Wiltshire Council Planning Consultation Response

Application No: PL/2026/02983 (LBC) and PL/2026/02709

Conversion and change of use of existing building to facilitate the provision of two (Use Class C3) residential units, and the demolition of existing building and erection of one (Use Class C3) residential dwelling with associated works
47 Blue Boar Row, Salisbury, SP1 1DA

14084.D04 structural repair details for attic roof

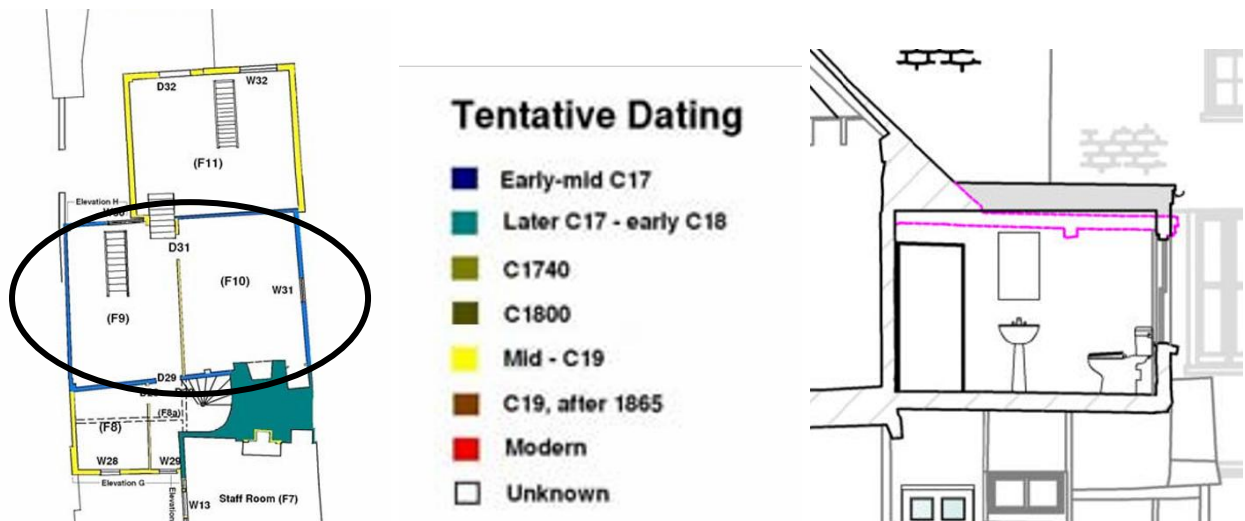
Note: the drawing says 'all timbers to be numbered and photographed and recorded prior to any work commencing'.

In respect of the attic roof repairs, as per the engineer's drawing 'all timbers to be numbered and photographed and recorded prior to any work commencing'.

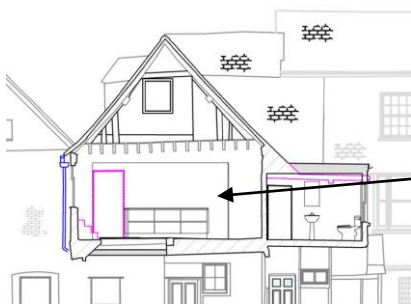
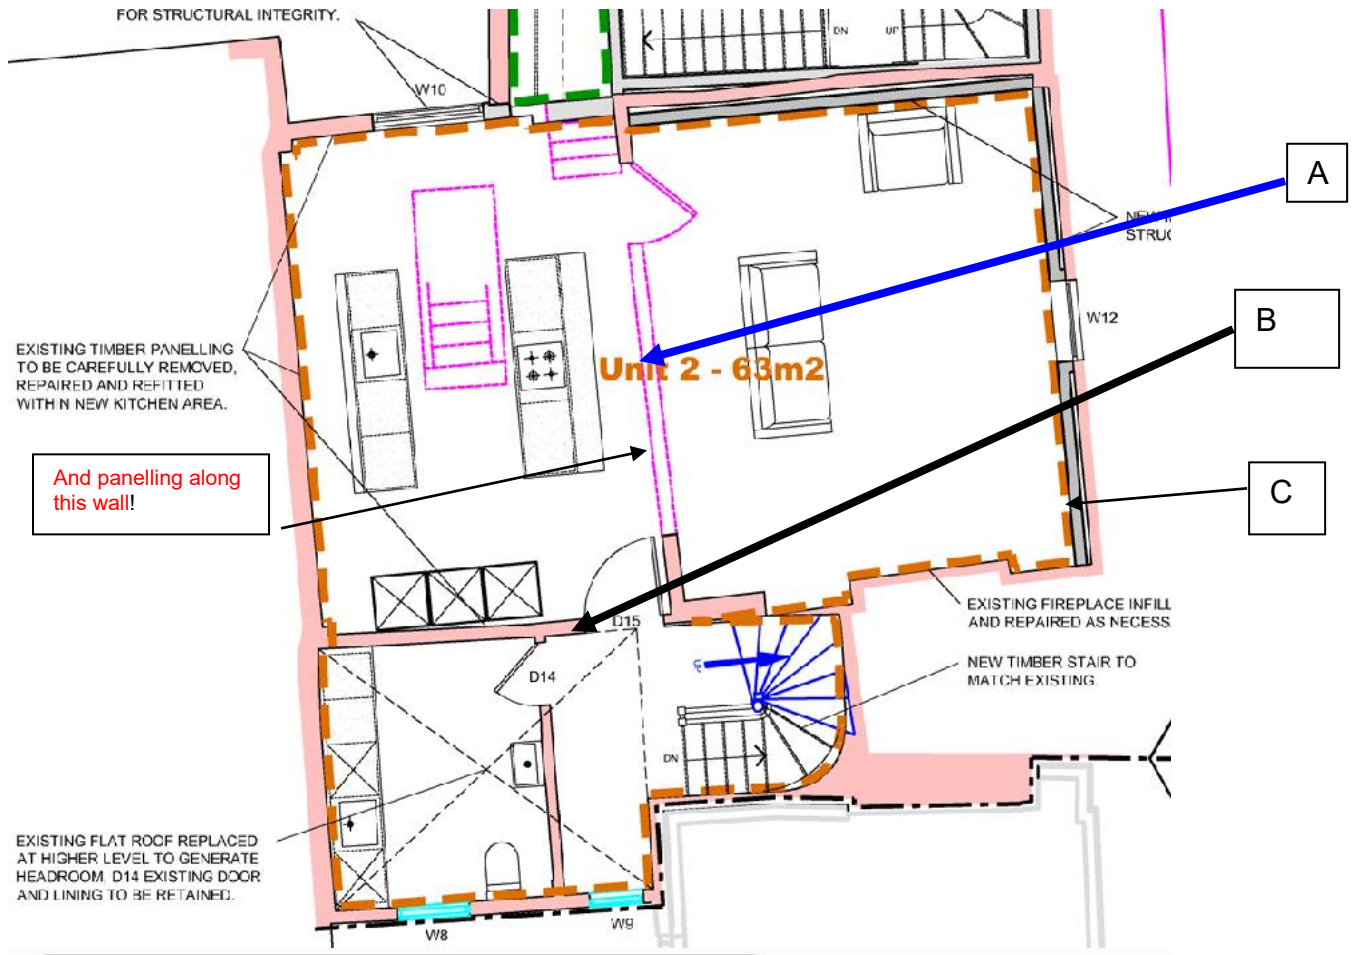
At first floor, the existing flat roof, the plans say, will be 'replaced at a high level' (see above snip). What impact will this have on the historic fabric? We needed a greater level of detail for this proposed element.

What happens to windows W8 and W9?

A new internal wall is installed (living room side) – northern wall. This covers an original wall (early-mid 17th century). I do not support this (as expressed at the site visit) although I note the engineer says: *The northern wall is saturated, and all the wall elements are totally decayed and beyond repair. The whole wall and roof valley area above will need to be replaced with new timber structure*.

The demolition of the spine wall (A on my plan below) is proposed. I do not support the extent of demolition (and, I said so in previous comments and at the site meeting). It is clear that this is the line of an original wall and as such, what ever the age of the existing fabric, it is a significant element of the building. It is also a wall against which the panelling (when it was a coffee shop) was erected. As such, the removal of the wall would also remove the ability to rehang the panelling (removed without consent by previous owners). I believe we discussed an enlarged opening ie double-door size.

And I also require clarification in respect of wall B.

Too large an opening. Entails the loss of too much wall

I would suggest that a new wall is installed on the far (northern side) and that the timber stud work is repaired or replaced and visible. Even if it ends up being largely replaced fabric, the character of the room and interest of the structure will be evident (with insulation between the studwork).

ELEVATION 05

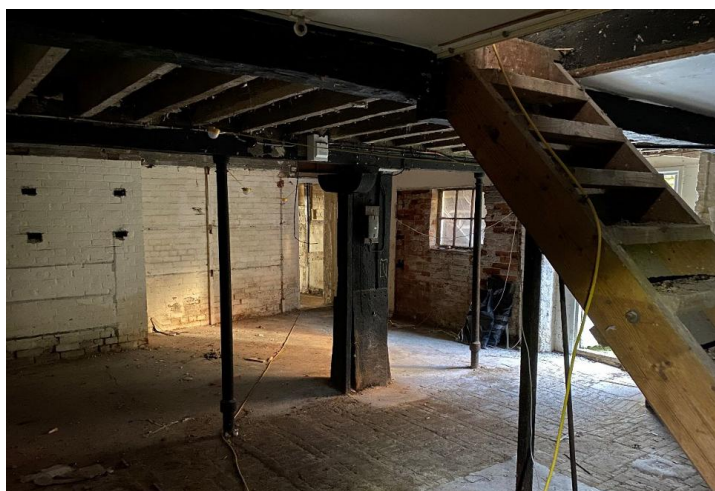
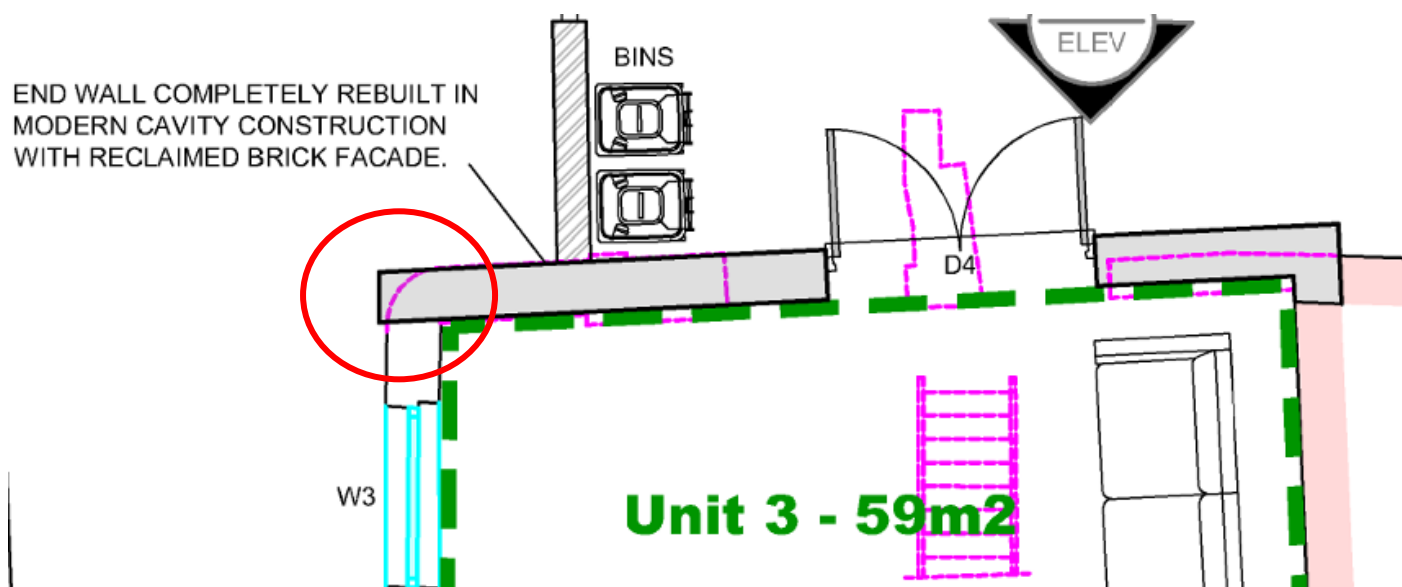
At first floor I suggest that the inner new staircase wall is the wall that is currently proposed for the inner wall of unit 2 (see previous comments). The current floor is floorboards. The new floor should be floorboards (Interestingly, the proposed plans show steps up to the first floor from unit 2, however, I am pretty sure that this floor is actually only accessible from the current stairs from the ground floor).

At second floor (which is accessible from the first floor of unit 2 currently), a bedroom and ensuite is proposed together with a new flight of stairs (as currently this room is only accessible from unit 2).

What happens to windows W1, W2, W3, W4, W11 and W20?

Greater detail of treatment within the threshold of the ground floor;

Details of the new French doors;

That the north elevation (to be rebuilt) is constructed in salvaged bricks or bricks to match existing and to match in bond and set in a lime mortar (panel to be agreed);

The corner of the building (ground floor) which is curved – should NOT be rebuilt

Windows to be repaired unless otherwise agreed in writing;

First and second floor shall be floorboards as existing
Arch to the new first floor rear window to match that of the ground floor (as existing);
Details of the new wall (ie height and brick and bond) as well as the gate, to unit 3's back garden;
Details of the existing paving to be lifted and relaid.
